RE: Overburden Soil Stockpile Sample Results
Solid Waste Management Unit (SWMU) 2
Tooele Army Depot South Area (TEAD-S)
UT5210090002

To: Allyn Allison, COR
From: Jeff Gunn, Project Manager
CC: Tracy Bergquist, Cathy Etheredge, Brian Barker
Date: 29 April 2014
Re: Recommendations for management of SWMU 2 Stockpiles 2, 3 & 4

RE: Overburden Sampling Memorandum
Phase II RFI Addendum for SWMU 2
Tooele Army Depot South (TEADS)
UT5210090002

RE: Incremental Sampling Plan
Solid Waste Management Unit (SWMU) 2
Tooele Army Depot- South (TEADS) UT5210090002

Figure 1 - Proposed Anomaly Investigation Trenches

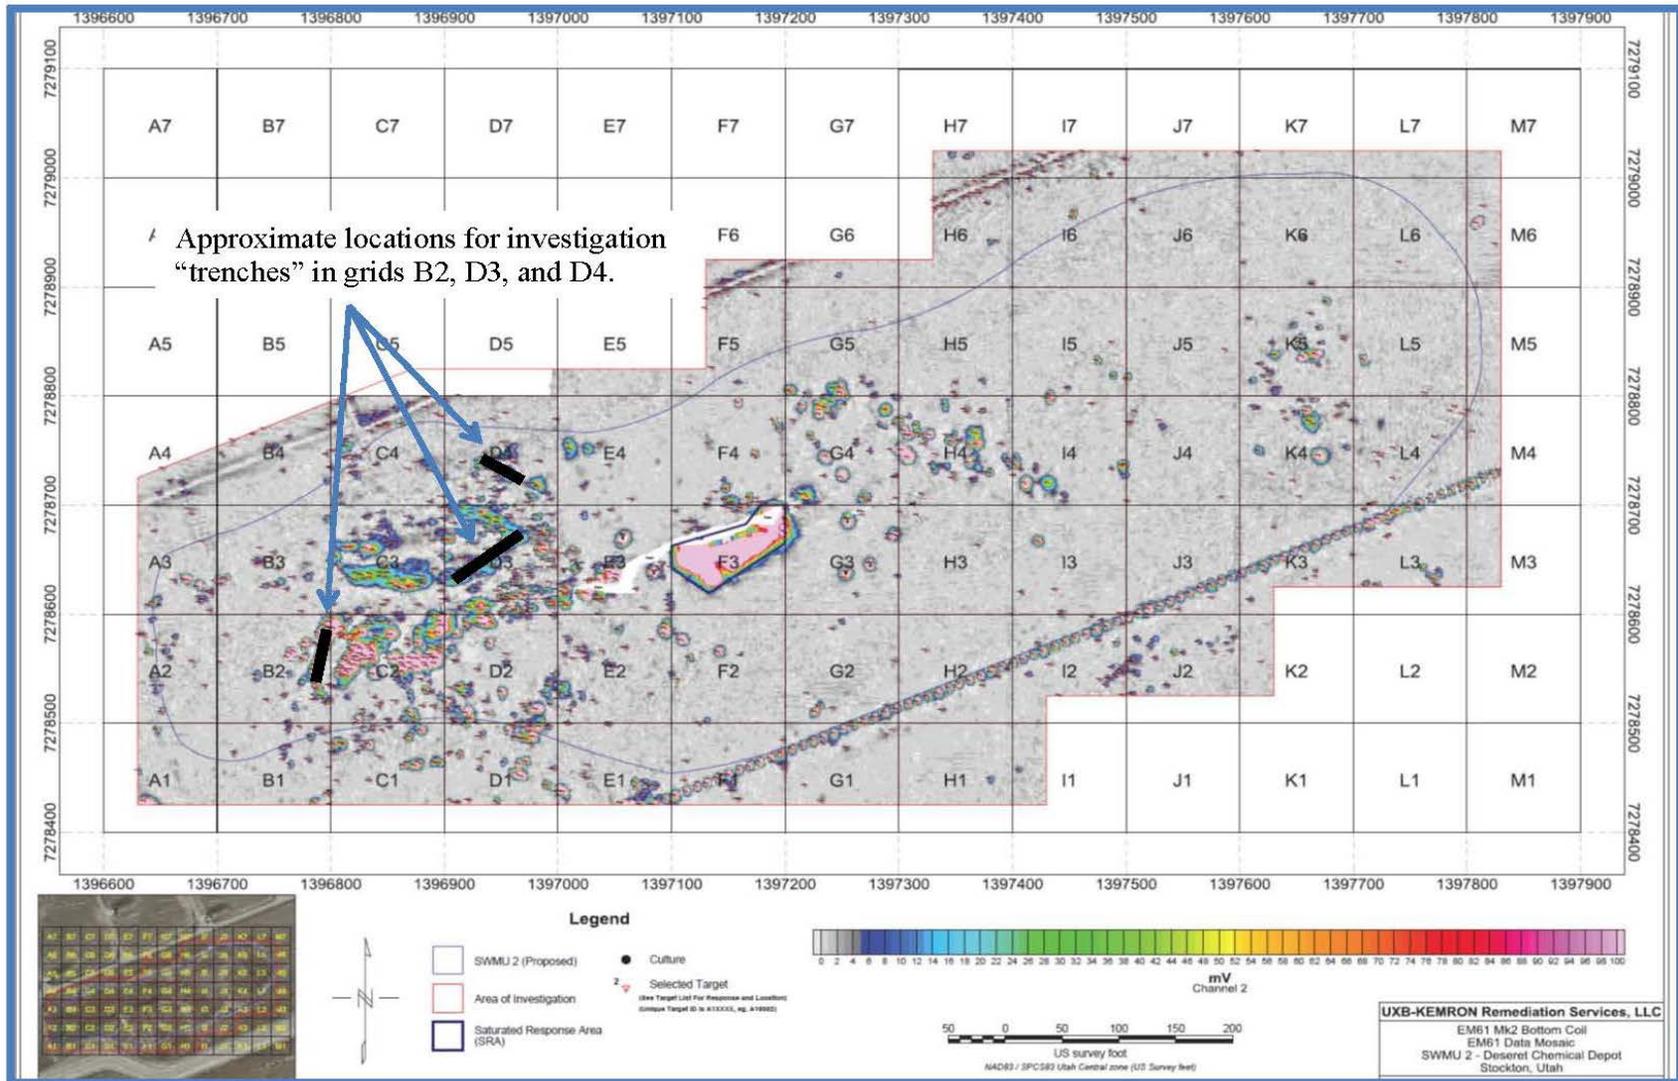
2. Trenching and confirmation samples - KEMRON proposes that a backhoe (or similar) be used to intrusively investigate a line (trench) across three grids (B2, D3, D4) within the highest density of geophysical readings as shown in Figure 1 (attached). The locations within grids B2, D3, and D4 are based on the geophysical readings and were discussed and agreed upon during a site walk with Division, facility, and KEMRON personnel. The width of the trench will be the width of the equipment bucket/shovel (approximately 2-feet in width). Depth of the investigation will be either to soil undisturbed by historic grading/borrowing activities or until excavation provides a rationale for any remaining signal to a maximum depth of 10 feet which is roughly the depth capability of the EM-61. Additional trenching will be conducted in D4 where some limited investigation has been conducted. The material and soil excavated from these areas will be placed on plastic and will be visually inspected. Alternatively, the trench areas in grids B2, D3, and D4 may be investigated as single point anomalies as described in the approved RIWP.

Figure 2

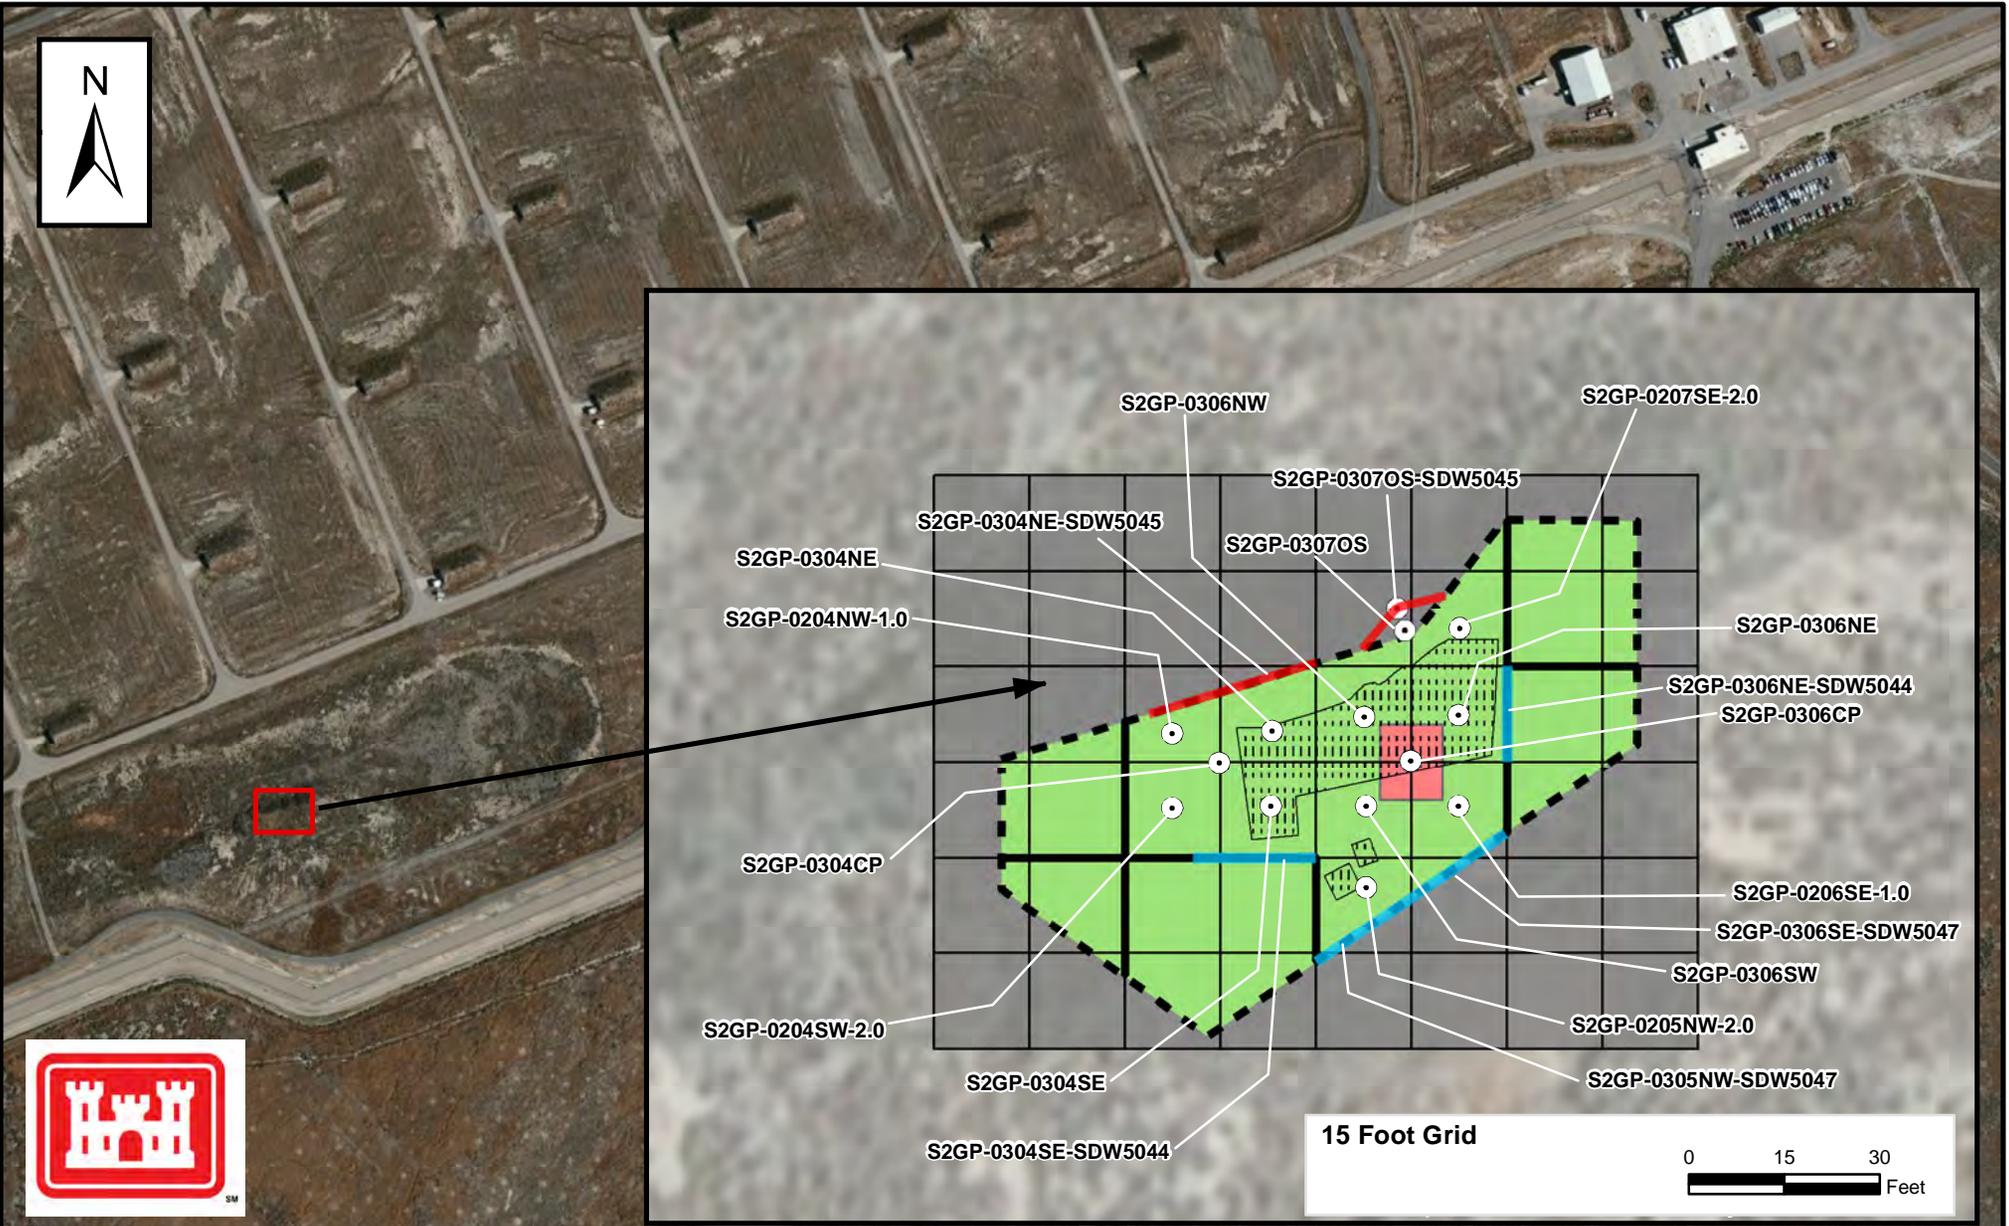
Post-excavation confirmation floor samples will be collected from the bottom of the 4' excavations to guide future site decisions. Confirmation floor samples will be collected from 0.0' to 0.5' bgs following excavation for VOCs, SVOCs, and metals along the same 15' grid used as a part of vertical delineation conducted in December 2014 (Figure 2).

Sidewall samples will be collected at a frequency of 1 sample per every 15 linear feet from soil representing the true sidewall of the excavation. Each sidewall sample will be collected as a 5-point composite at 2-foot intervals and analyzed for VOCs, SVOCs, and metals. VOC samples will be collected from the center of the sidewall, two inches below the surface of the sidewall. Proposed sidewall sample collection design is presented in Figure 2.

Additional delineation of the Burial Pit floor was conducted during Round 2 confirmation sampling (denoted by the suffix S2GP-02xx). Subsurface soil samples were collected along a 15-foot grid using Direct Push Technology (DPT) to 3 feet below ground surface (bgs) to further refine the footprint of source contamination. Round 2 residential and/or soil-to-groundwater exceedances were flagged for excavation as presented in Table 1 and on Figure 1. Round 2 exceedances again included hexachloroethane and arsenic, as well as compounds not previously detected above criteria including hexachlorobenzene, pentachlorophenol and tetrachloroethene. Excavation proceeded in 1-foot lifts or 4-foot lifts depending on the extent of contamination identified during Round 2 sampling. Some portions of the Burial Pit floor were over-excavated to simplify field operations and to ensure removal of potential source material, including an area of staining identified near the northern boundary of the Burial Pit. All stained soil was removed in this area, in the vicinity of S2GP-0307OS as shown on Figure 2.

Figure 2 - Proposed Decision Units for Multi-Incremental Sampling

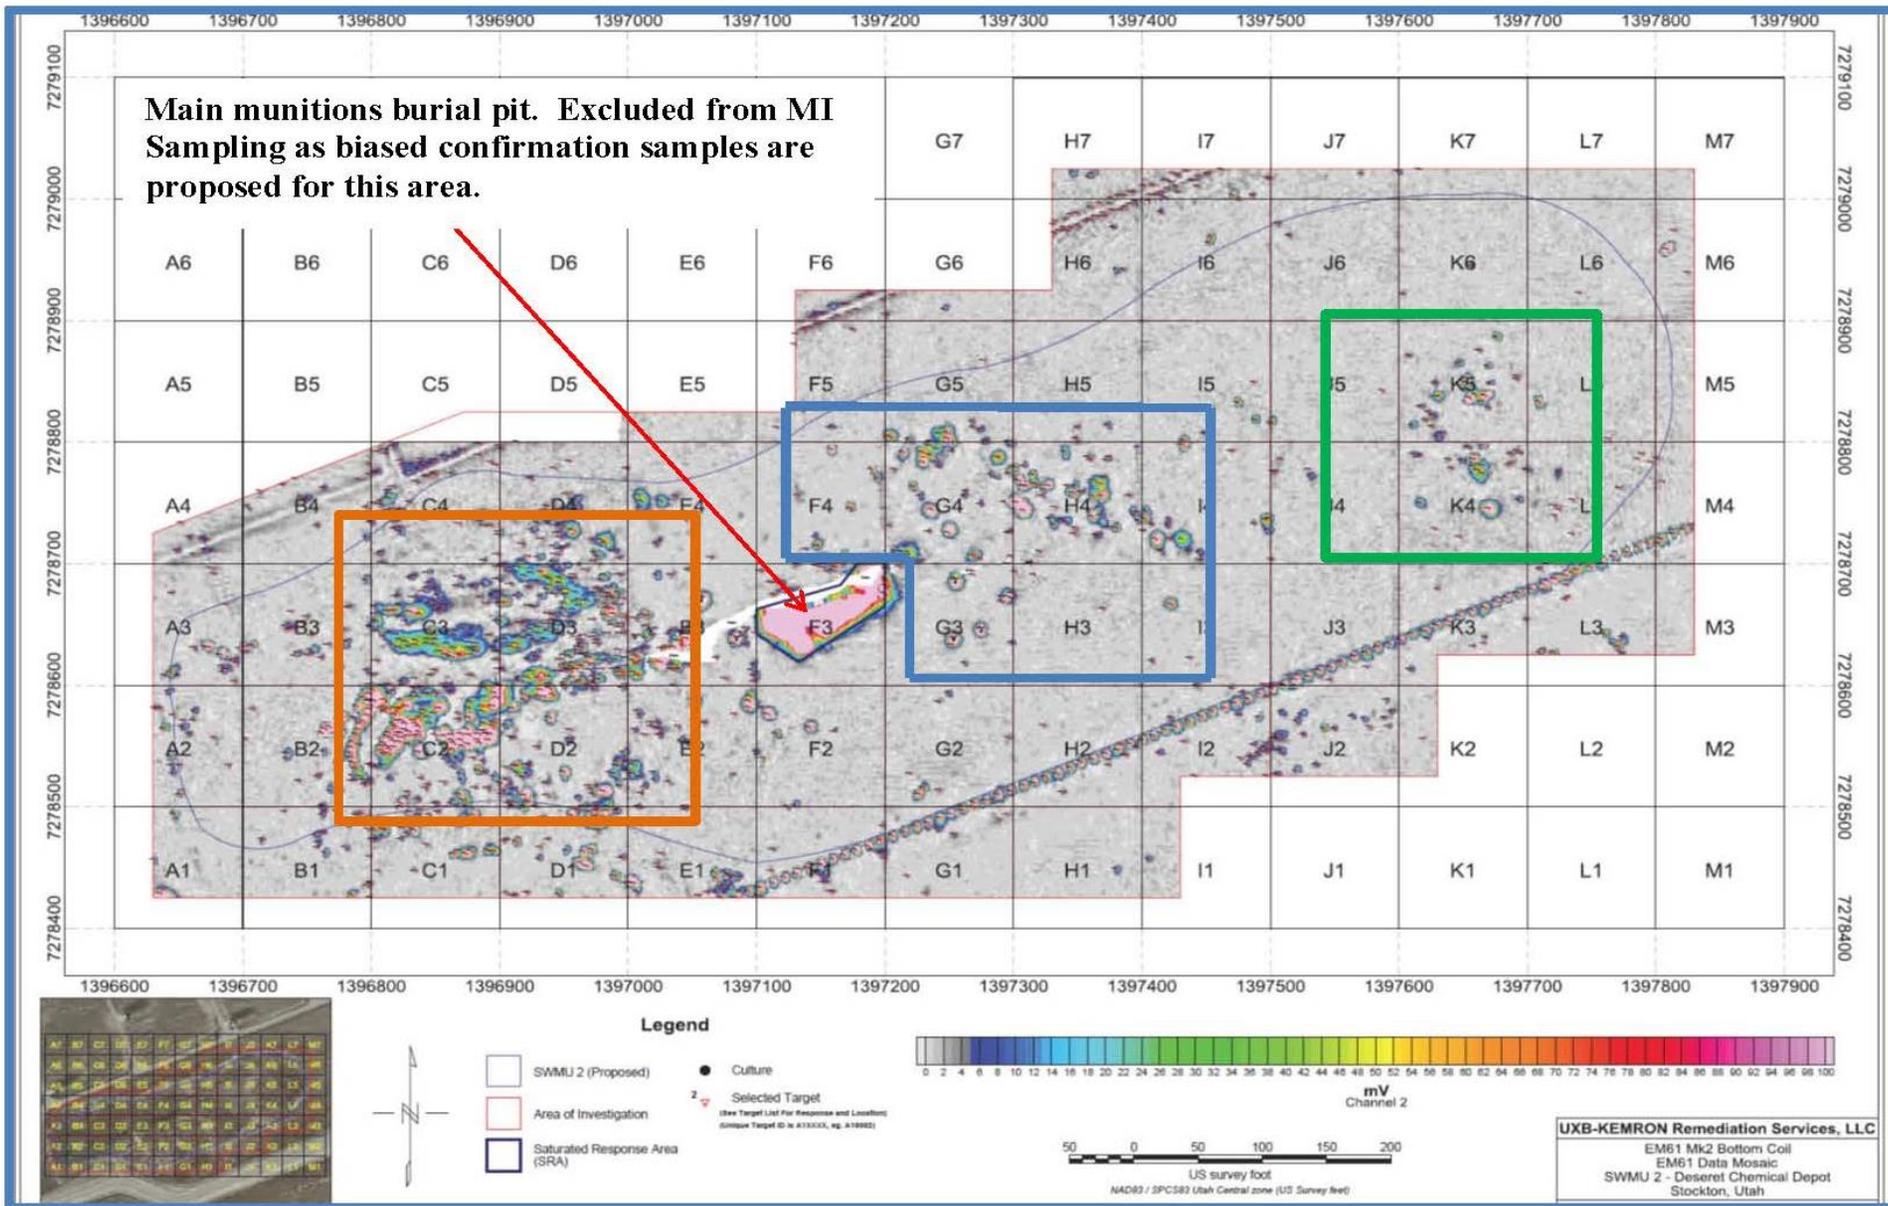
The revised incremental sampling plan for SWMU 2 is hereby approved. Responses to comments and the background sampling location are acceptable. In the CMI report, please provide documentation regarding laboratory sample processing as outlined in sections 7.0-7.2 of the plan. TEADS has indicated both incremental sampling and sampling in the main excavation area will begin September 15, 2014.
